Your Comment on the Rangitooopuni application

Thank you for referring the Rangitootuni fast-track consent (**the Project**) to Auckland Transport (**AT**) for comment. AT is a Council-Controlled Organisation and the Road Controlling Authority for the Auckland region (excluding the State Highway network). AT has the legislated purpose to contribute to an 'effective, efficient and safe Auckland land transport system in the public interest'¹. In fulfilling this role, AT has an interest in the Project as Road Controlling Authority and as an asset owner.

- Annexure A, Technical Note by Martin Peake, Progressive Transport Solutions Limited, dated 10 September 2025; and
- Annexure B, Stormwater Management Memo by Griffin Benton-Lynne, AWA Environmental Limited dated 12 September 2025

Figure 4 – Proposed Access 1 Layout with visibility splays highlighted

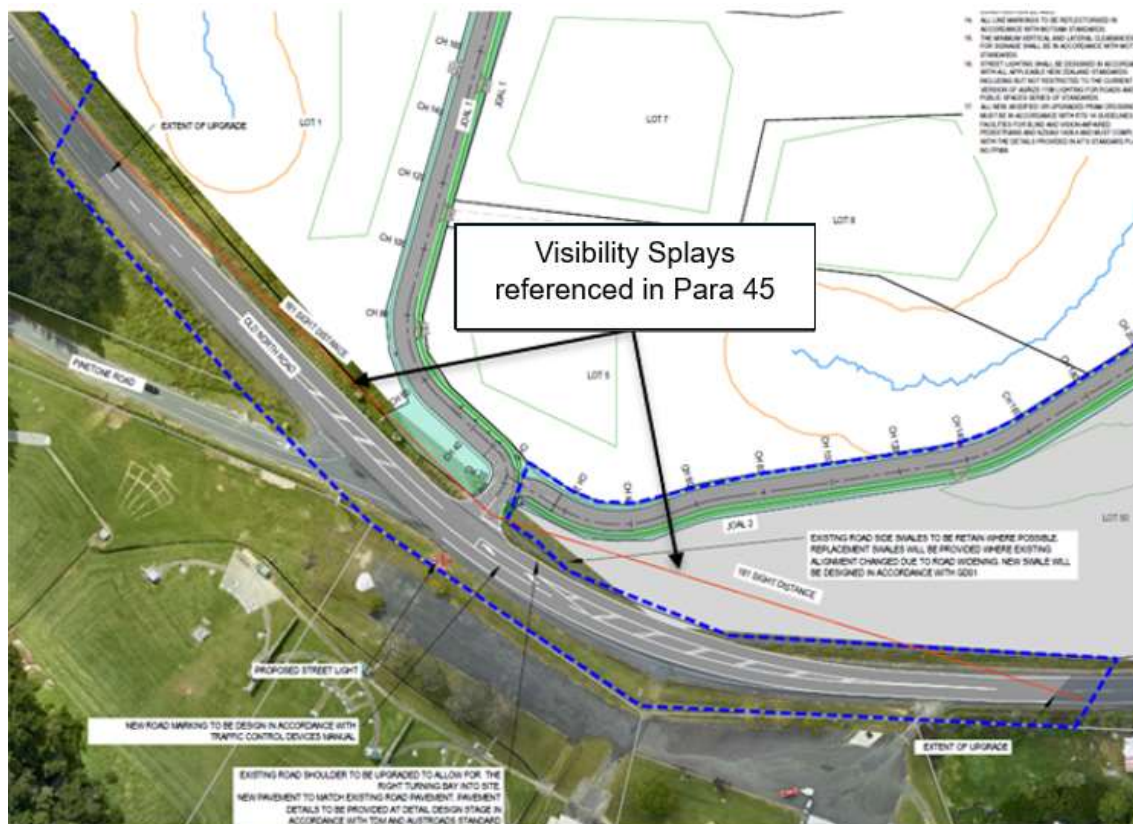
44. The existing site access on Old North Road will be upgraded with a right-turn bay and flush median. However, the design does not fully account for nearby Pinetone Road. It is recommended that right-turn movements to and from Pinetone Road be better integrated into the design. Final details can be resolved during the EA process, and sufficient land appears to be available for any required widening.
45. Visibility splays are generally acceptable, with a land covenant proposed to maintain sightlines to the east. To the west, vegetation and embankments may need to be removed or modified.

46. Vehicle tracking shows a 10.3m truck slightly encroaching into the right-turn bay, which will need to be addressed at the EPA stage. The access splits into two JOALs, and while queuing is expected to be minimal, the design should ensure vehicles can enter without being blocked by outbound queues.
47. Gates are proposed for both JOALs and will be set back at least 6m, forming a T-shaped turning head to allow vehicles to turn around safely if needed.
48. Access 1 is within 10m of Pinetone Road, triggering vehicle access restrictions under AUP Rules E27.6.4.1(2) and (3). While this requires assessment as a restricted discretionary activity, there are no existing safety concerns, visibility is adequate, and the access is not expected to impact the safe or efficient operation of the road network. Pinetone Road is a low-volume cul-de-sac.

Figure 6 – Deacon Road / Riverhead Road Intersection

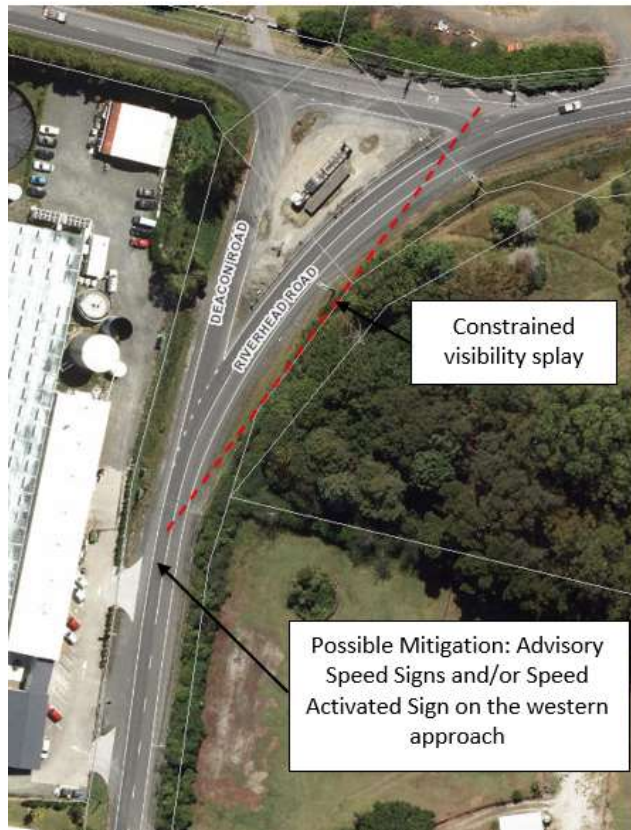
59. The ITA has reviewed the safety record of the Deacons Road / Riverhead Road intersection and identified a crash trend, particularly involving right-turning movements. Visibility from Deacons Road to the west is limited—only about 120m is available versus the 181m required for an 80 km/h design speed. This shortfall is likely contributing to the crash trend.
60. Although the proposed development does not directly affect visibility, it would triple the volume of right-turning traffic from Deacons Road during the AM peak, increasing crash risk exposure. Mitigation measures such as advisory speed signs or speed-activated warning signs on the western approach are recommended to improve safety (refer to Figure 6).

Figure 4 - Proposed Access 1 Layout with visibility splays highlighted

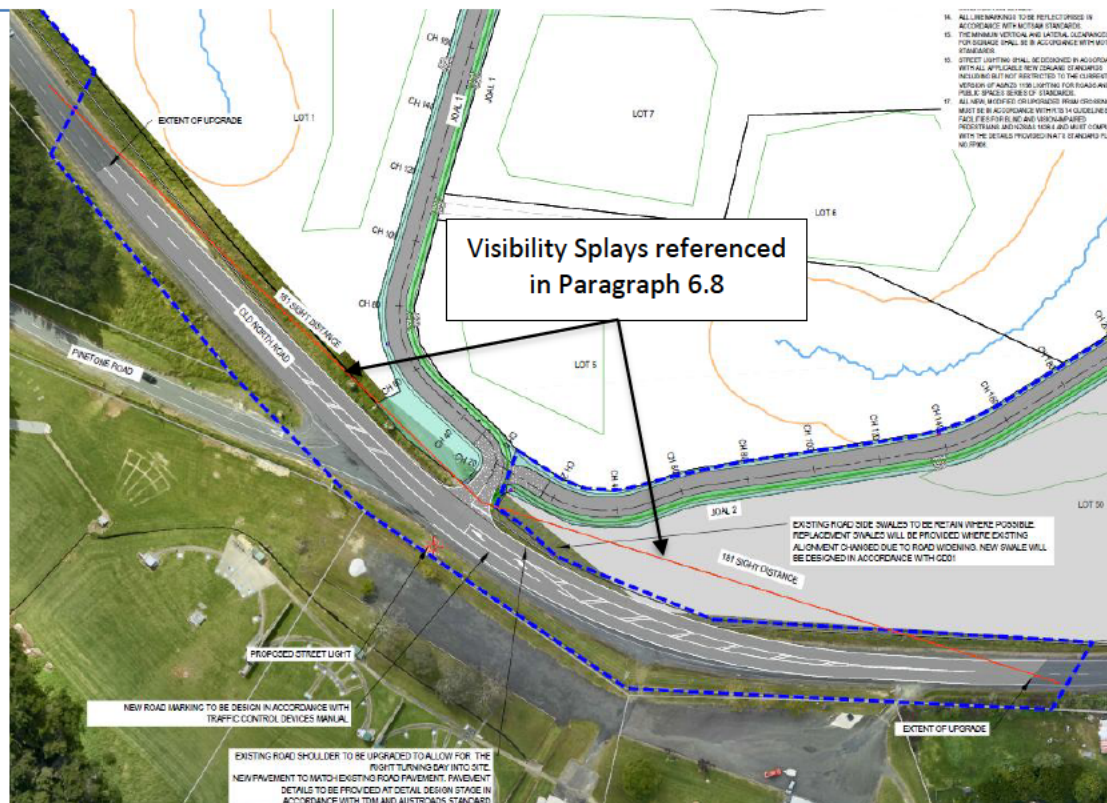
- 6.8 The visibility splays for the intersection extend over the berms either side of the access. The Scheme Plan drawings indicate that the land to the east of the vehicle crossing would be subject to a land covenant to maintain the sight lines east of the access. This is considered appropriate as vegetation may grow over time that could block the sight lines to the east. To the west of the vehicle crossing, there is a berm and embankment. It is considered that the bank and vegetation would need to be removed or modified to maintain the sight lines. This is highlighted in Figure 4.

- 6.9 The Scheme Plans show that some of the land along the site frontage either side of the vehicle crossing will be vested. The extent or form of any modifications for this land to create the vehicle access is not clear.

- 6.10 Vehicle tracking for the vehicle access shows that a 10.3m truck extends slightly into the right turn pocket. The design will need to be adjusted so that the truck will not conflict with a vehicle waiting in the right turn bay. This is a matter of detail that can be addressed at EPA stage.

Figure 6 - Deacon Road / Riverhead Road Intersection

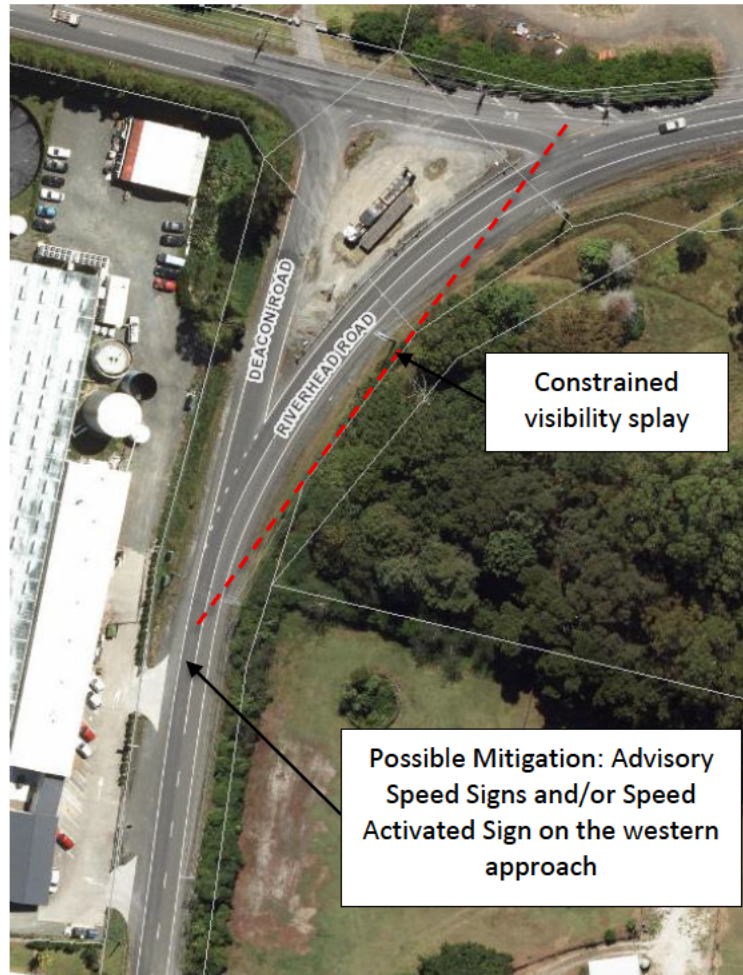
visibility at the intersection, it does triple the right turn volume from Deacon Road in the AM peak⁸ thereby increasing the crash risk exposure.

- 6.34 Mitigation measures may be appropriate, such as advisory speed signs or speed-activated warning signs on the western approach to the intersection (refer to Figure 6).

Figure 1: Post Development Depth Map Provided by the Applicant

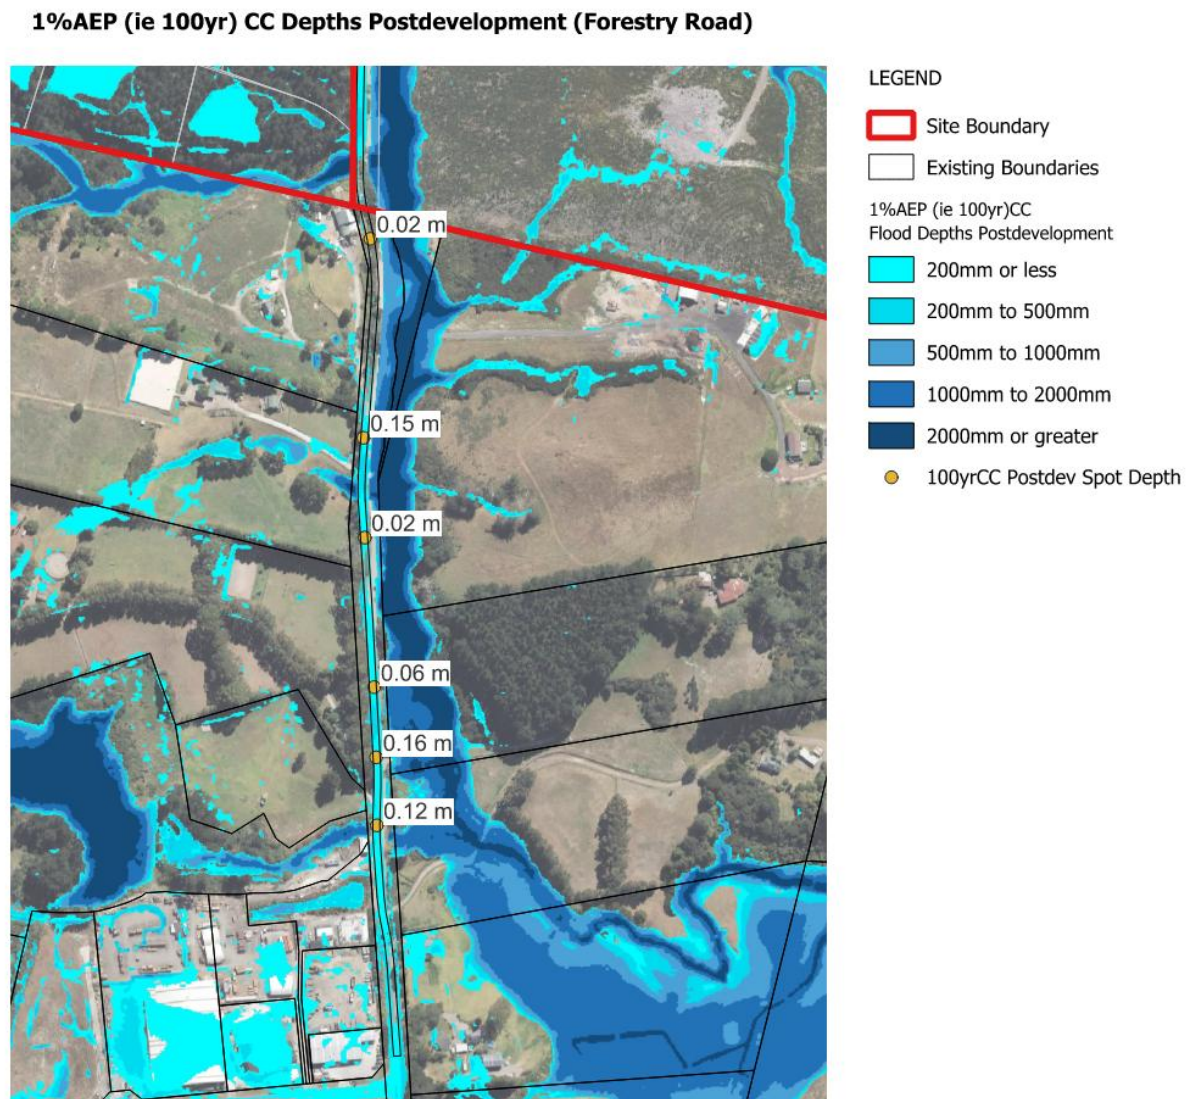
3.7 A zoomed-in map of the existing road was provided by the applicant, titled '*1%AEP (i.e 100yr) CC Depths Postdevelopment (Forestry Road)*', which shows the flood depths within the area of Forestry Road, as well as some specific points depths within the road (refer to Figure 1 below). However, these points are located on either side of the worst-case locations within the road, i.e., 64 and 85 Forestry

Road. In these two locations depths exceed 200mm, which contradicts the applicant's assertion in Section 9.2 of the Flood Risk Assessment that following raising the road the maximum depths do not exceed 200mm. It is not clear what the actual modelled depths are, but the legend indicates these two areas are between 200 – 500mm in depth. The worst-case depths should be confirmed as excessive depths could prevent the ingress and egress of emergency services and may be hazardous to road users.

- 3.8 The two areas described above in 3.7 appear to be areas of transverse flow. No assessment of the energy grade line has been provided, and it has not been demonstrated that these areas are safe for vehicles to traverse.
- 3.9 The comparison maps provided show the difference in water level for the pre-development and post-development scenarios, but no depth comparison maps are provided. While water level differences can be useful in assessing the impacts of the proposal, the key information is the depth difference as depth is directly related to hazard, while water level is not necessarily. This is especially true when the

- 5.2 Zoomed-in maps should also be provided so that it can clearly be seen where the worst-case locations are, and these should be labelled to clearly show the maximum values.
